Strategic regional water resource solutions:

Accelerated gate two final decision for water recycling

Strategic regional water resource solutions: accelerated gate two final decision for Water Recycling

Figure 2. Assessment of progress and quality of investigation

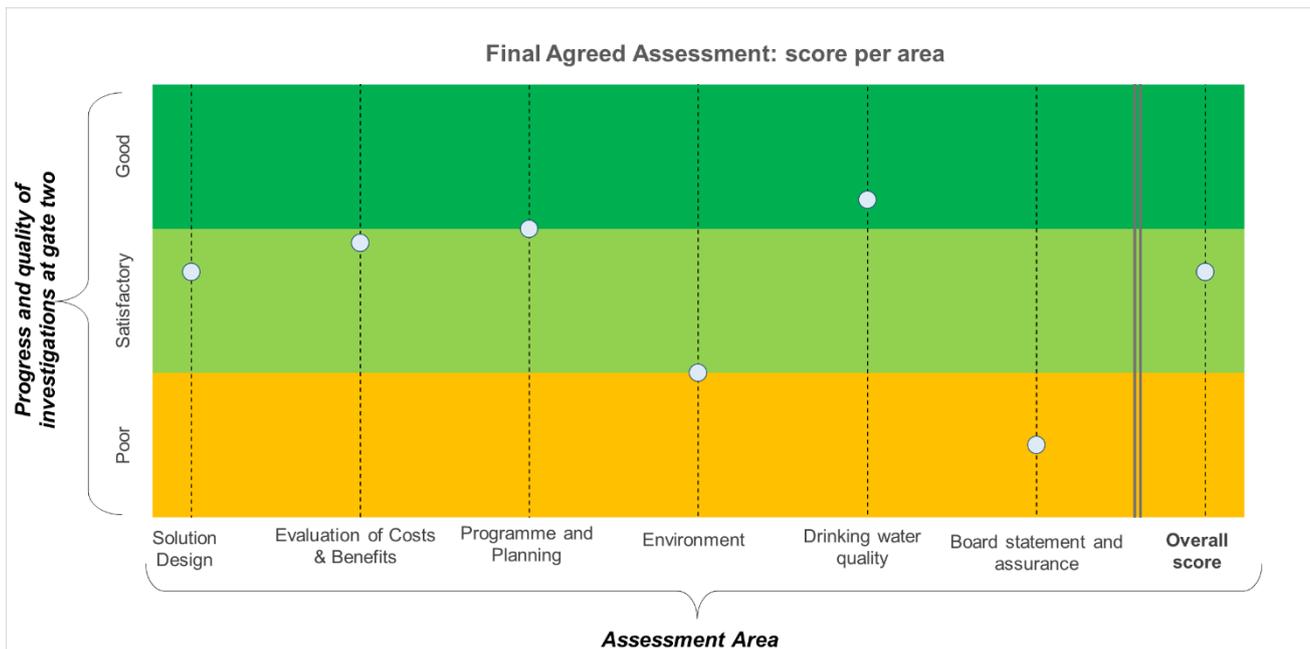
Figure 2 shows our assessment of the work completed on the solution, which was presented in the submission. Our assessment was made against the criteria of robustness, consistency, and uncertainty to grade each area of the submission as good, satisfactory, or poor in accordance with [accelerated gate two guidance](#) published on 22 February 2021 and updated in June 2021. We also assessed the Board assurance provided.

Our overall assessment of the work completed on the solution as at accelerated gate two is that it is satisfactory overall, but it falls significantly short in some important areas and is not as developed as would be expected at this stage. We explain where we have found shortfalls in the progress made and work completed on investigating and developing the solution below.
